RE: HVAC Work for KEEN 3rd Floor Server Room; Cooling Units, Roof Top Condensing Units & Piping
Application 12-172563-000-00-FA
Structural Plan Check Response

Below is our response to the structural plan check sheets that we received from the City of Portland Bureau of Development Services dated September 27, 2012. This response is intended to be reviewed in conjunction with the attached structural calculations and drawing SK1, dated September 27, 2012.

SK1 CONNECTION BETWEEN ROOFTOP & SLEEPER

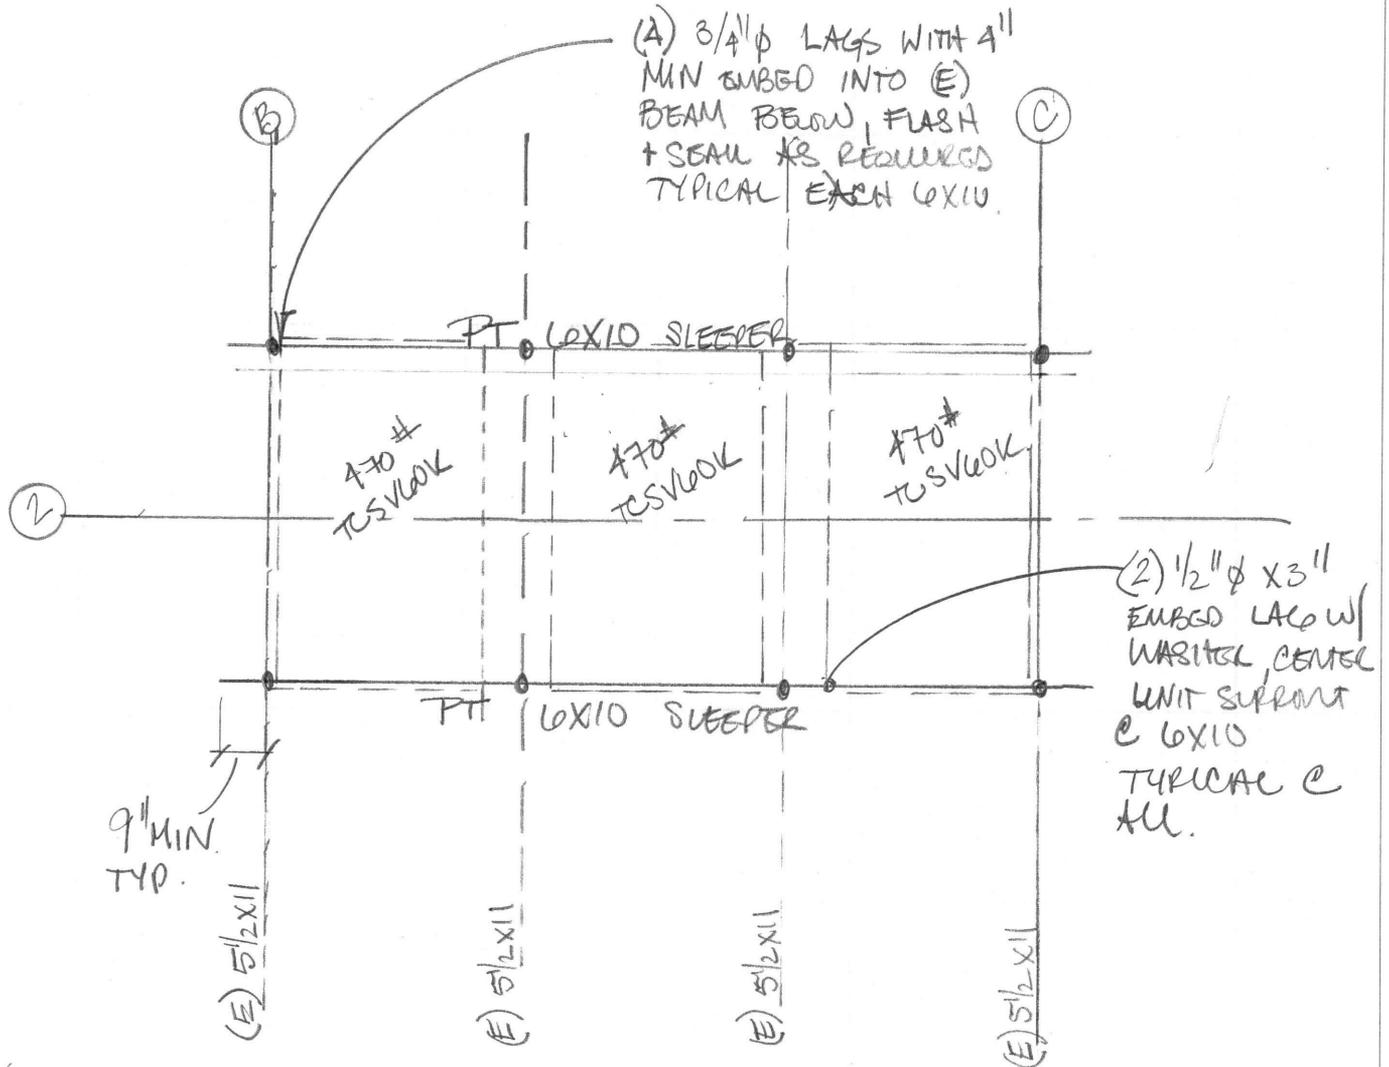
The detail for the attachment between the rooftop condensing unit sleeper and the roof structure is indicated to be by others. Please provide the detail for that connection.

KPFF: Please reference sheet SK1 for the connection detail.
